SAFETY RECALL BULLETIN

NHTSA RECALL 21V149

AUTOCAR, LLC SAFETY RECALL DC-2102

Autocar, LLC has determined that a defect which relates to motor vehicle safety exists on certain DC chassis, the steering column tilt control cable may contact the steering shaft.

Figure 3

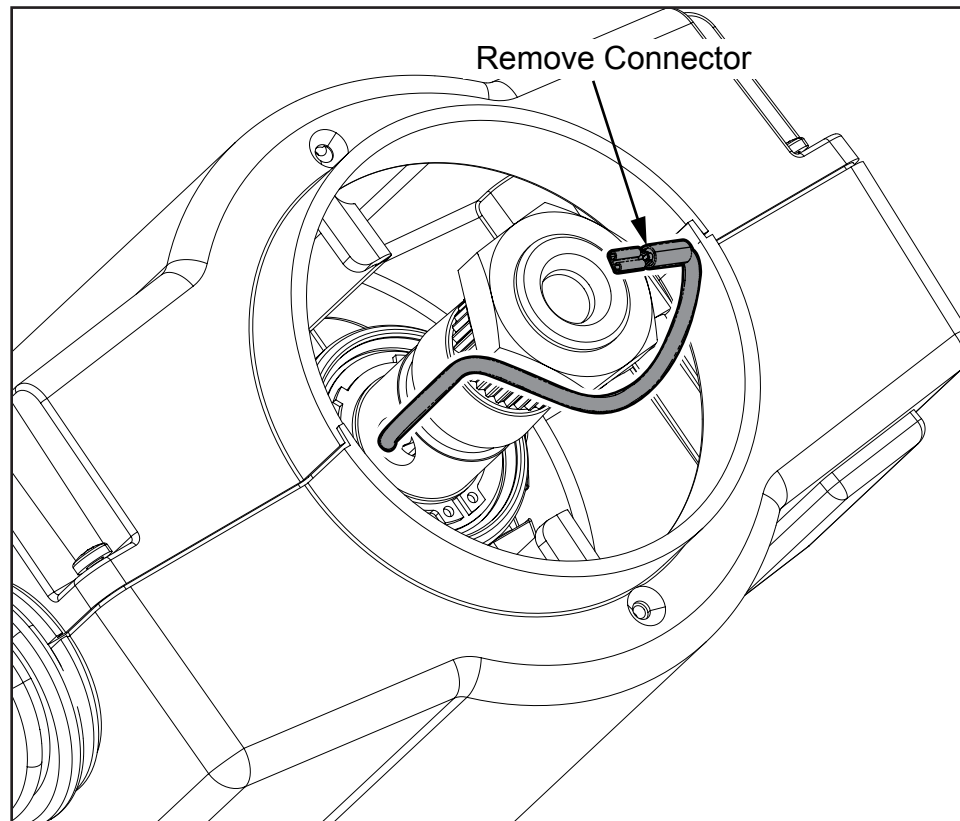
4. Locate the end of the horn wire, cut off the connector and discard (see *Figure 3*).

Figure 4

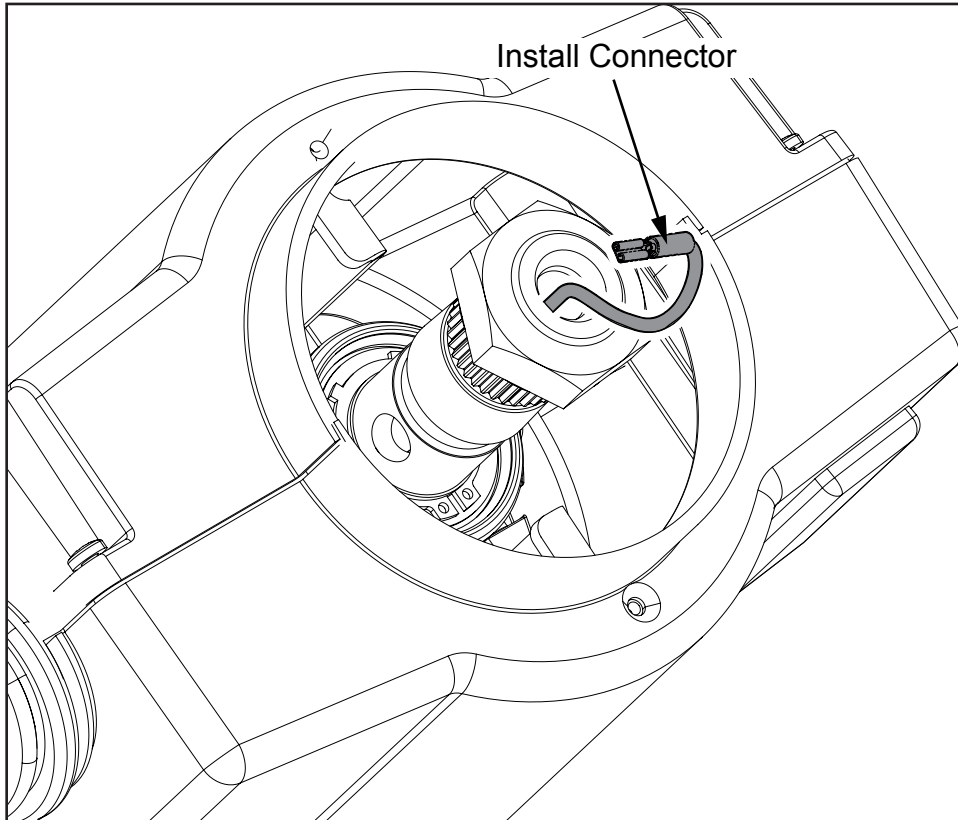
5. Reroute the horn wire through the center of the steering column shaft. Using a crimping tool, Install (1) S3800001-001 connector to the end of the horn wire (see Figure 4).

Figure 5

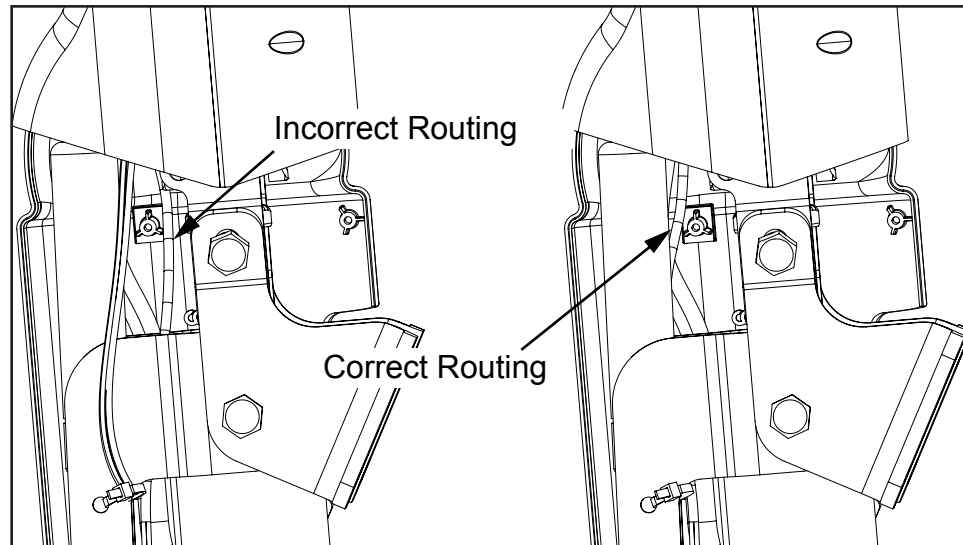
6. Verify that the tilt column cable is installed correctly. The cable must be secured at the shaft housing and in front of the boss on the cover panel, **NOT BEHIND**. Verify the routing of the cable does not allow the cable to come in contact with the yoke (see Figure 5).

Figure 6

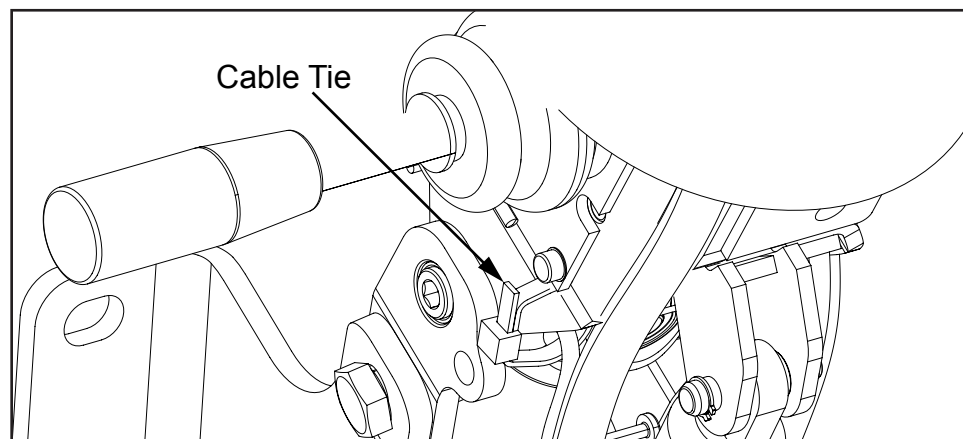
7. Using (1) 948210 Cable tie, secure the tilt cable as shown (see Figure 6).
